# Technical Bulletin

## No. Barbara-001

### Parts List Corrections

FAX RF01/02, FAX240

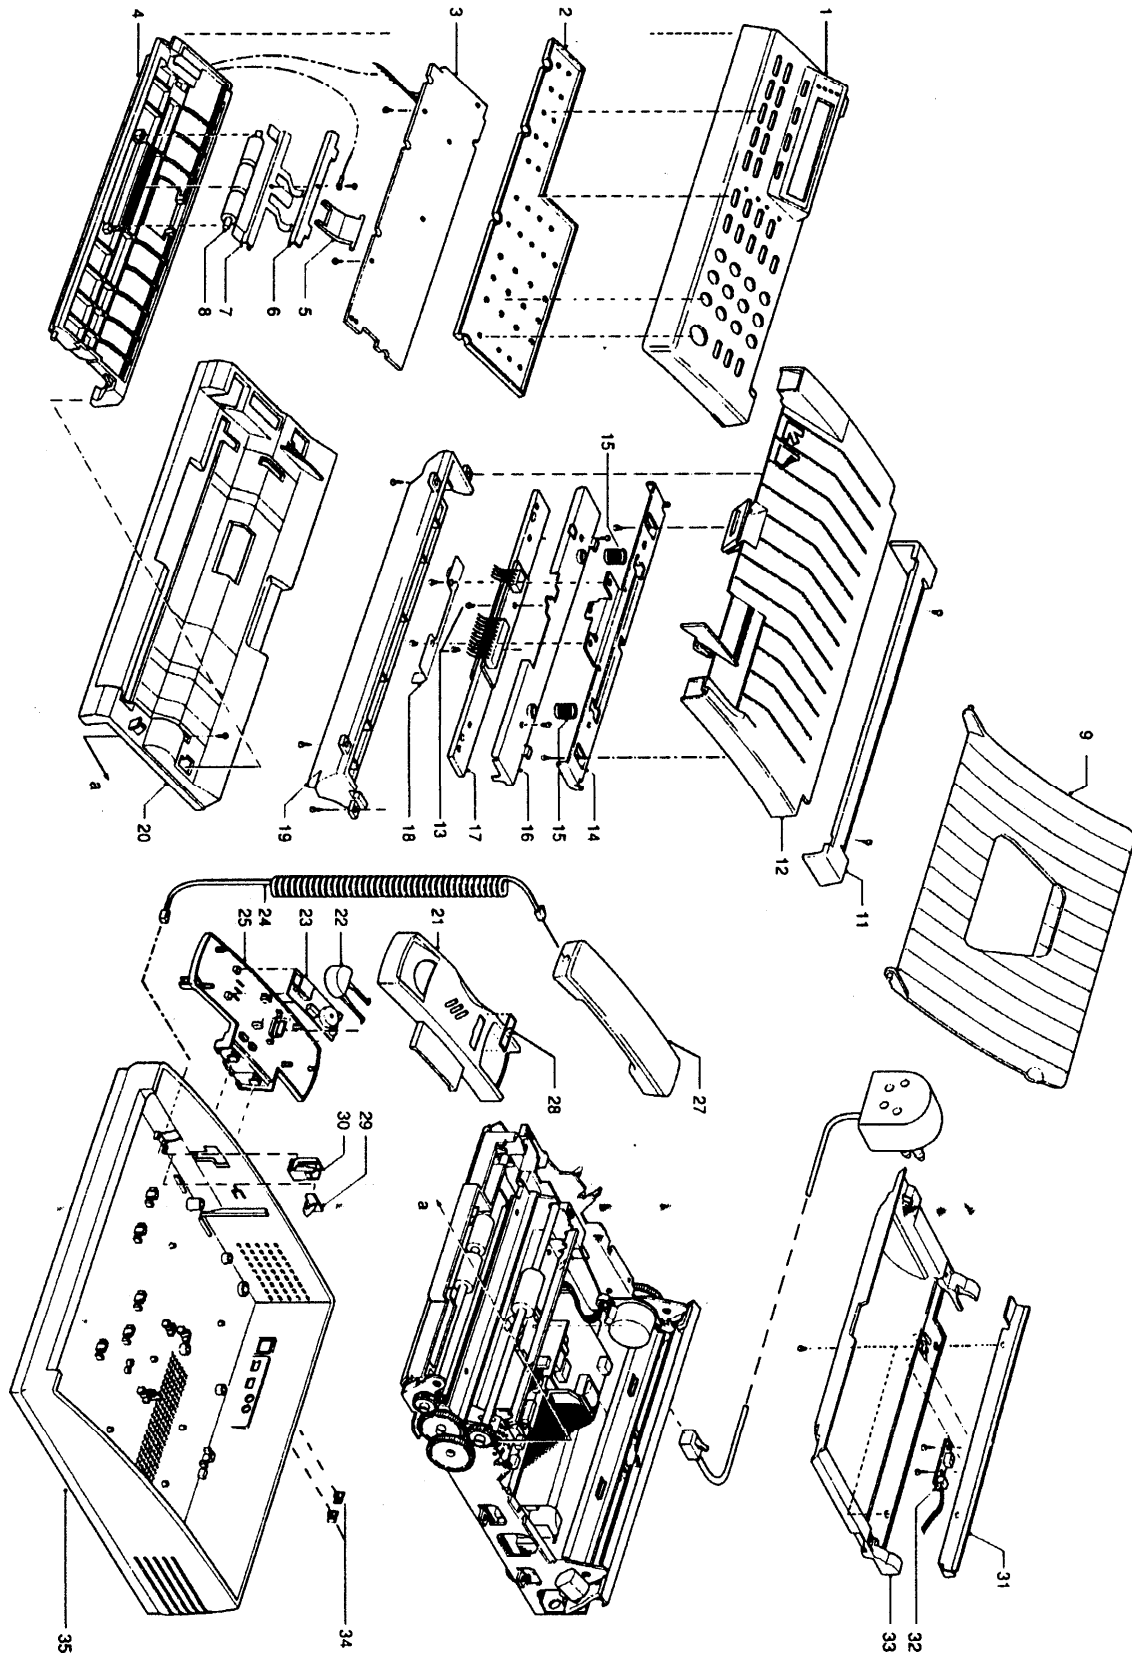
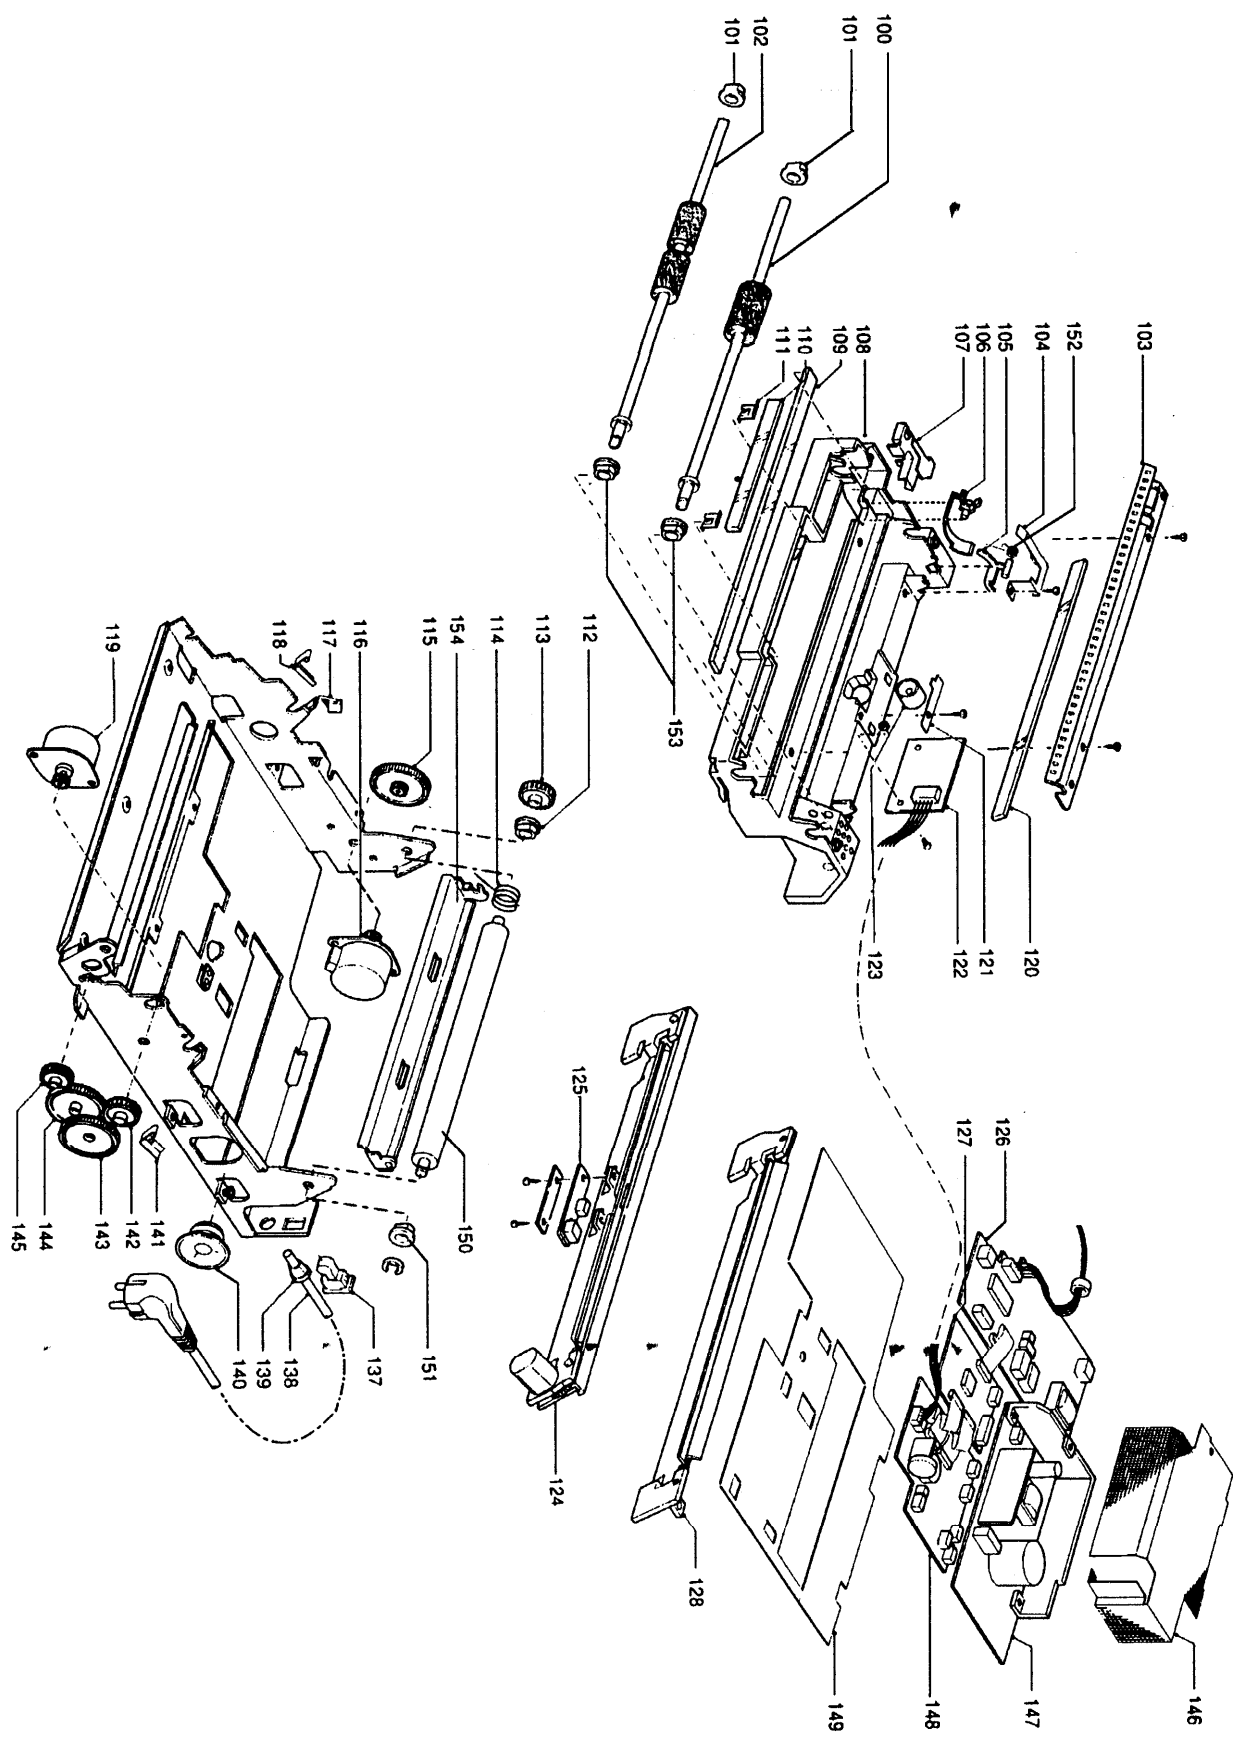
Index	Part No.	Description		RF01	RF02	FAX240
2	H0948508	OPU Rubber Mat - FAX240	New			○
140	H0535023	Monitor Speaker - P/# corrected		○	○	○
*	H0937711	Spring Washer - Thermal Head	New	○	○	○
*	H0937712	Washer - Thermal Head	New	○	○	○
*	H0937713	Screw - M3 x 5	New	○	○	○
	H0938107	Quick Dial Label	New		○	○

Note that the part number of the monitor speaker listed in the service manual was wrong. Use "H0535023" for further ordering.

A full set of latest parts list with exploded view is enclosed.

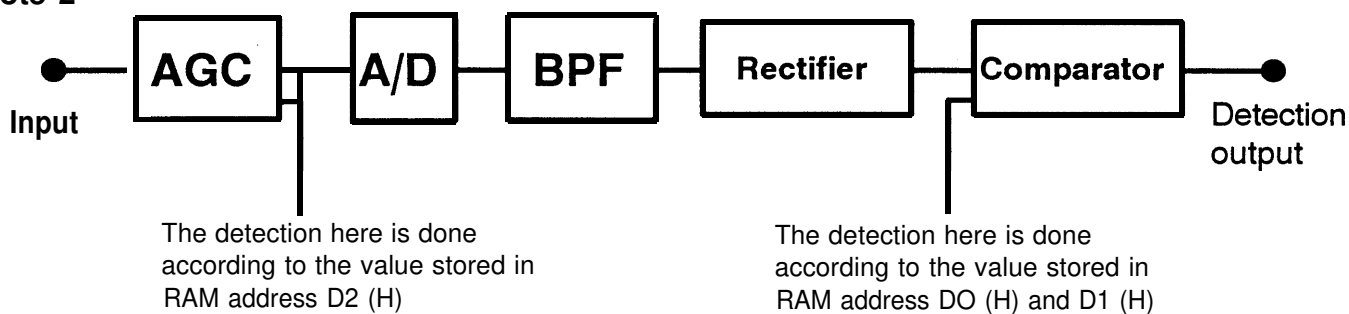
The additional RAM addresses are as follows.

Description	Address (H)	Default (H)	Calculated Value
CNG hysteresis	D0	02	}-18dB *Note 1
CNG hysteresis	D1	00	
CNG detection level (Min.)	D2	5A	5A (H) x 0.375 = - 33.75dB *Note 2
CNG non detection period	D3	00	00 (H) x 0.16 (sec.) = 0 sec
CNG silence detection period	D4	. FA	FA (H) x 0.16 (sec.) = 40 sec }*Note 3

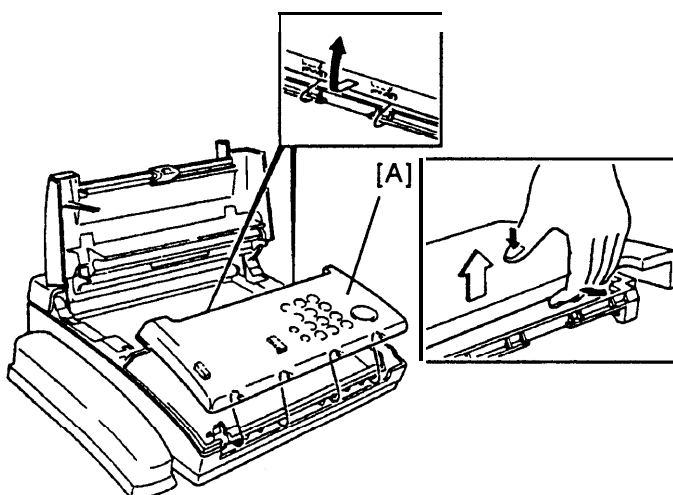
Tx image or copy image is abnormal (e.g. all black) after transportation.

The 1st mirror was knocked out of position during transportation.

We will add two stopper ribs for the first mirror.

Attach the two rubber feet according to the attached procedure.

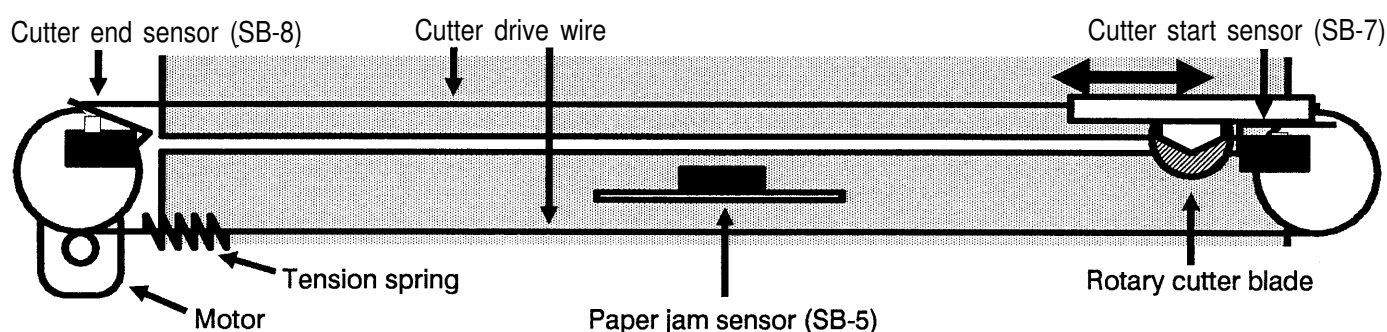
The machines with automatic paper cutter may indicate "REMOVE PRINTOUT / ADJUST FAX PAPER" on the LCD display frequently, and the cutter may not work correctly.

The cutter start position sensor (SB-7) and/or the cutter end position sensor (SB-8) is/are defective.

Replace whole cutter unit or defective sensor(s). The part number of the microswitch which is used as these sensors is;

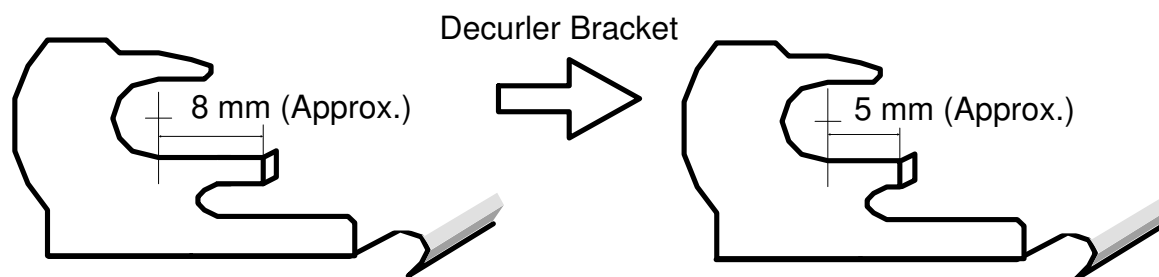
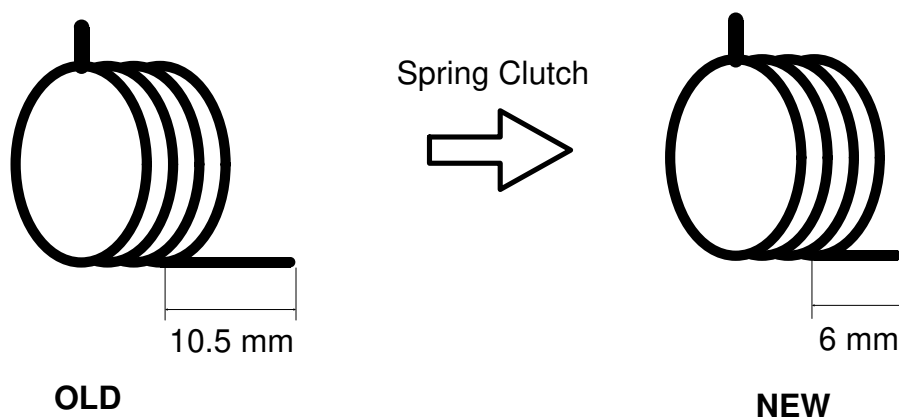
The thermal head surface might be scratched by the spring that is used as spring clutch for decurler.

The decurler bracket and the spring clutch have been modified as follows. Use the new parts as a set for future replacement.

Index	Old P/#	New P/#	Description	ICA
154	H0947709	H0942121	Decurler Bracket	X/O
114	H0937701	H0942120	Spring Clutch

Fig.-1 (Circuit Diagram - R801, R802, R811)

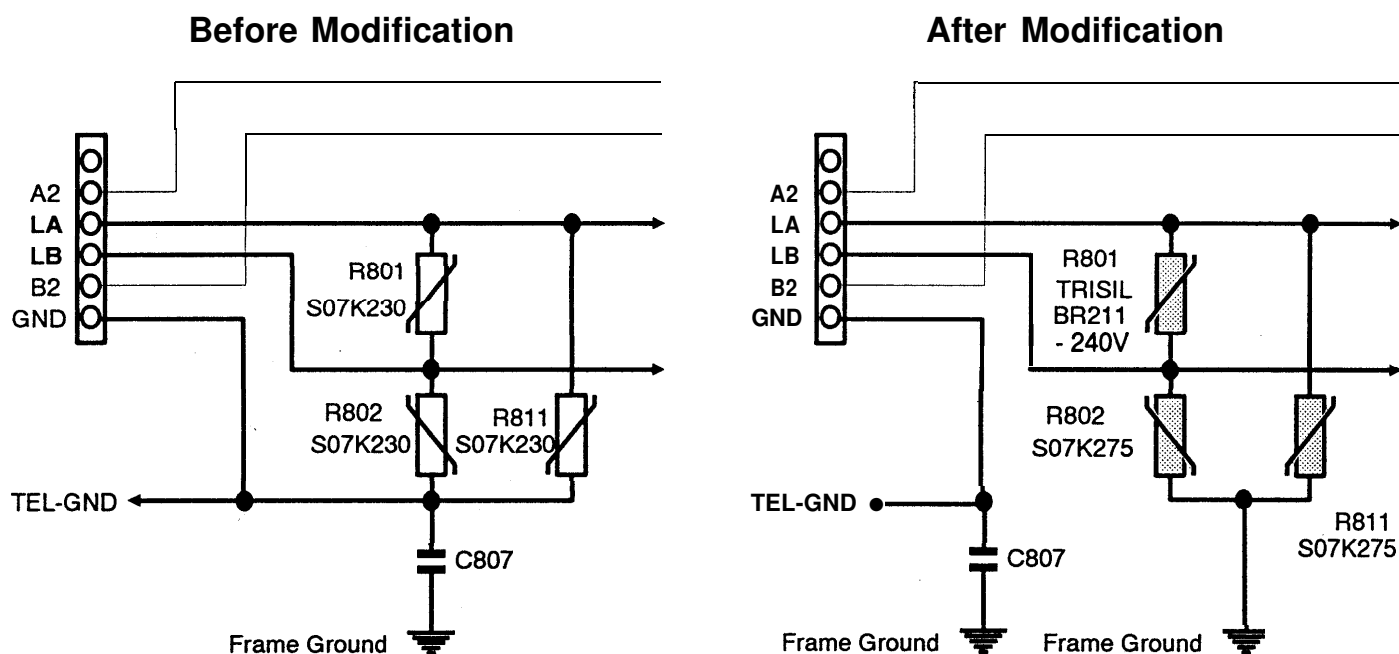
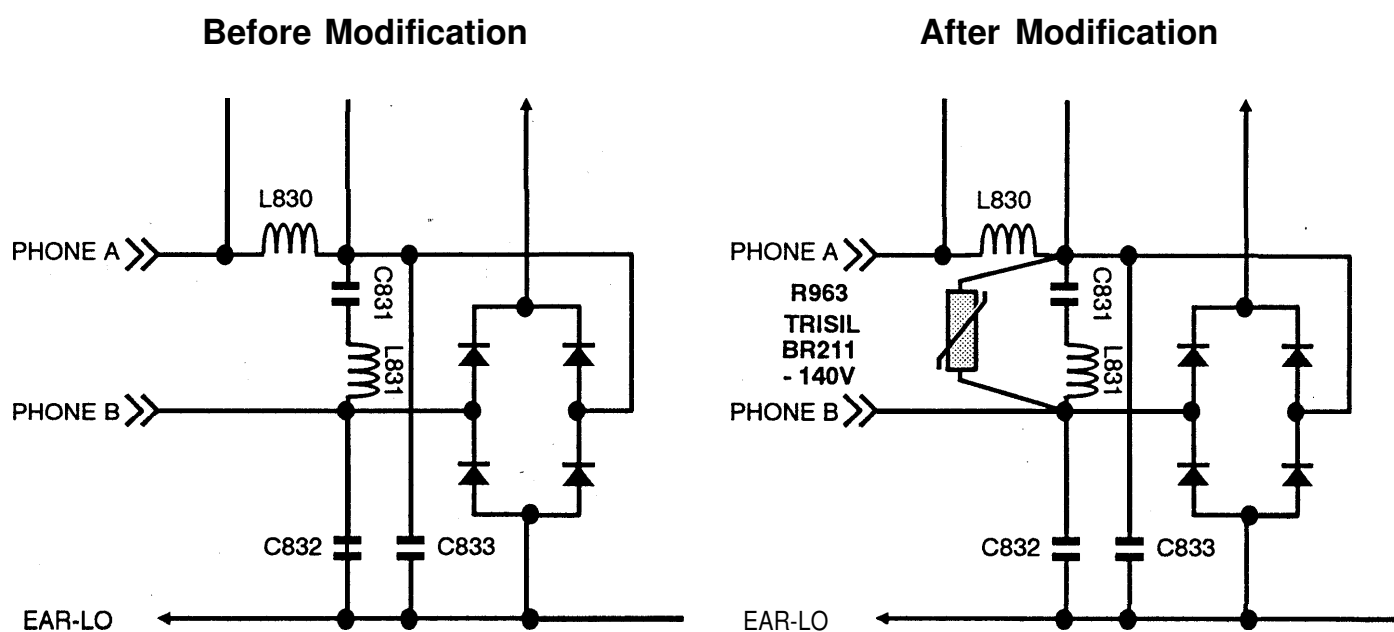
Additionally, the following components have to be added on the LIU board as shown in the enclosed diagrams (fig.1, 2 and 3), to protect lightning damage.

Location	Ricoh P/#	PHILIPS P/#	Description
R801	H0947114	933882070113	Trisil Diode - BR211 -240V
R963	H0947115	933882020113	Trisil Diode - BR211 -140V
R802	H0947116	211255000077	Varistor - SIOVK275
R811	H0947116	211255000077	Varistor - SIOVK275
